## Appendix A Response to Government and Agency Submissions

The following is a response to the full text of submissions provided by or on behalf of State and local government agencies. For completeness, the full text of each submission is provided in the left-hand column, accompanied by the proponent's corresponding response in the right-hand column. The proponent's responses have been informed by input by the expert consultant team, and should be read in conjunction with the publicly exhibited Environmental Impact Statement and accompanying technical reports, as well as the Response to Submissions Report to which this document is appended.

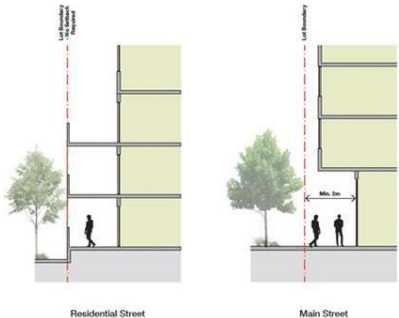
Road Connection: Future road for connection to Peach Tree Road on the northern side of the site has not been shown on the Master Plan. Although this road is not shown in the Access Network in Part 4.5 of Ryde DCP 2014, a future road connection has been discussed with the applicant. Such a road will increase the permeability throughout this area. Council seeks that a clear gap be provided between Building B2 and B1.2 to enable road connectivity to Peach Tree Road as demonstrated in Figure 1. This gap will need to accommodate a 14.5m wide road as well as the appropriate setback.	The refined Masterplan includes a potential future connection to Peach Tree Road. This is shown on the Envelope Control Plan at <b>Appendix C</b> .

Issue	Response
	<p>up to the bridge. Low voltage street lighting will be required, but the verge in this area is at least 3.5m wide and can therefore accommodate it.</p> <p>The servicing alignments shown on sheet 501 of the engineering DA set show that the utilities can adequately be provided in the vicinity of the intersection between Mains Street and Road No 2. The intersection of Herring Road and Main Street is to be designed to RMS specifications and is based upon traffic modelling to the RMS's satisfaction, with storage bay lengths designed accordingly.</p> <p>RMS have advised that they will not support a right-turn movement out of the subdivision onto Epping Road for the final option, accordingly, south bound travel on Road No 3 is limited to between Main Street and Road No 2. Due to the RMS imposing a no right turn condition, the objectives of the DCP in using Road No 3 as another site exit point cannot be met. Due to the fact that Road No 3 will now act as a Local Street and not a Collector Street, a width of 14.5m is suitable and in accordance with Council's DCP.</p>

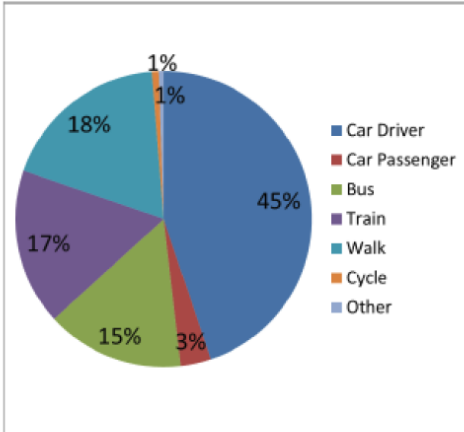
TMAP does not address the mid-block and intersection capacity of the proposed internal roads within the Ivanhoe Estate development.

It is recommended that the TMAP be updated to include an assessment of the internal roads within the Ivanhoe Estate development taking account of Council's comments on traffic generation estimate. In particular, a single lane street may not be adequate to cater for 510 vehicle trips during the AM peak hour, attempting to utilise school drop-off/pick-up facilities.

Refer to the updated drawings provided by Bates Smart and contained in the Transport Management and Accessibility Plan Addendum.

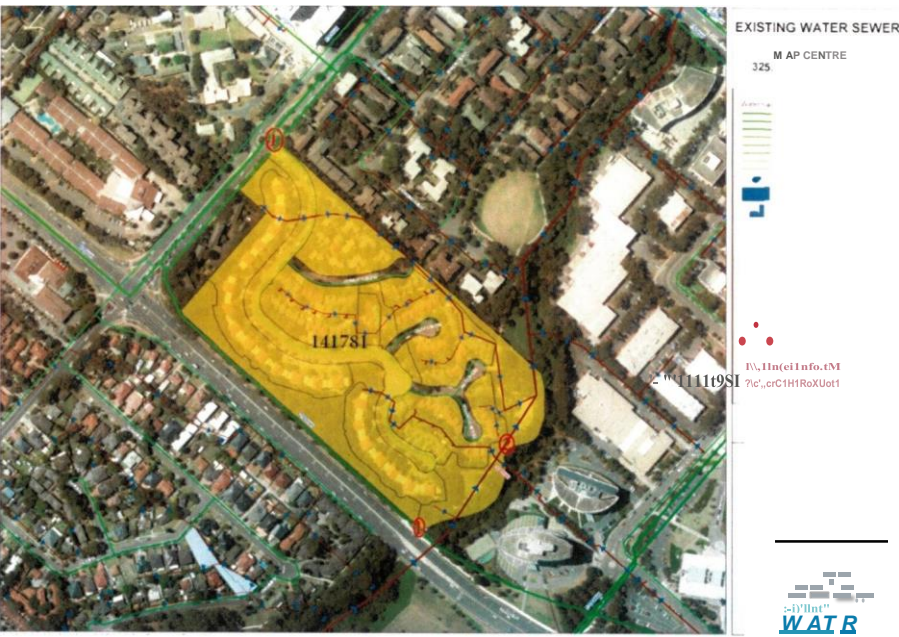
<ul style="list-style-type: none"> <li>Principle 1 of the NSW Biodiversity Offsets Policy for Major Projects states that "Before offsets are considered, impacts must first be avoided, and unavoidable impacts minimised through mitigation measures. Only then should offsets be considered for the remaining impacts." It is considered that the proposed development fails to avoid direct impacts on threatened ecological communities. It is not considered that adequate planning/siting of the proposal has been carried out as per the Framework for Biodiversity Assessment (FBA). Specifically, the FBA requires proponents to identify and avoid direct impacts to threatened ecological communities (TECs). An alternative footprint design could avoid impacting on the EEC particularly the STIF EEC primarily located along the perimeter of the sites southern boundary. There is opportunity to reduce the building footprint than currently shown in Figure 1 below and this could be achieved with higher building forms, with increased buffers and setbacks to this EEC or relocation of development.</li> </ul>	<p>The proponent has redesigned the project and has avoided areas of EEC, where possible. The reduced design is presented within the updated BAR.</p> <p>The reduced footprint includes consideration of ecological value, as well as other design constraints for the site.</p>

<p>Further, the consultant's Eco Logical Australia Biodiversity Assessment Report and Offset Strategy dated February 2018, Section 6.1.3 Table 14 states as follows - the Major Project should be located in areas where the native vegetation or threatened species habitat is in the poorest condition (i.e. areas that have a lower site value score) or which avoid an EEC or</p>	<p>As above, the proponent has redesigned the project and has avoided areas of EEC, where possible. The reduced design is presented within the updated BAR.</p>

Issue	Response
CEEC... minimise the amount of clearing or habitat loss - the Major Project (and associated construction infrastructure) should be located in areas that do not have native vegetation, or in areas that require the least amount of vegetation to be cleared (i.e. the development footprint is minimised, and/or in areas where other impacts to biodiversity will be the lowest.	The reduced footprint includes consideration of ecological value, as well as other design constraints for the site.
OEH suggests the development footprint could be reduced and higher building heights could be proposed to preserve more STIF. It is noted that a 65m height control (equivalent to 21 storeys based on 3m floor to ceiling heights) is proposed along the southern boundary to Epping Road, refer to Figure 2 below. The consultant's report does not assess what the impact is on the vegetation remaining from overshadowing and limited light especially vegetation along Epping Road where a 65m height is proposed and where good quality STIF is located. The proponent should calculate the reduction in the conservation value of the remaining patch of vegetation not just the areas that are removed.	<p>As above, the proponent has redesigned the project and has avoided areas of EEC, where possible. The reduced design is presented within the updated BAR.</p> <p>The reduced footprint includes consideration of ecological value, as well as other design constraints for the site.</p> <p>ELA notes that the existing development currently shades portions of the STIF onsite. The future development may exacerbate this impact, however the effects of this are difficult to quantify. In addition, the FBA does not assess impacts of a proposal that are not associated with clearing of vegetation. ELA recommends implementing a monitoring program (as specified in future VMP for the site) to assess ongoing impacts to STIF.</p>
